## ***Interactive comment on “Granite micro-porosity changes due to fracturing and alteration: secondary mineral phases as proxies for porosity and permeability estimation” by Martin Staněk and Yves Géraud***

**S. Marti (Referee)**

Received and published: 14 November 2018

**Fig. 1.** Schematic sketch of rock core and sampled materials

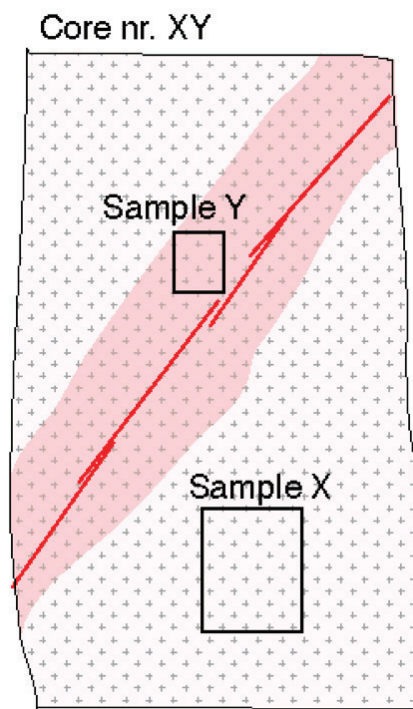
Additionally, it is somewhat tedious to keep track with all the different microstructures that the different samples are associated with. To help clarity in this case, I would suggest changing the sample photographs in Figure 4 to schematic sketches of the cores, their alteration structures etc. and their relation to the sampling location (something along the lines of the figure attached at the end of this review)
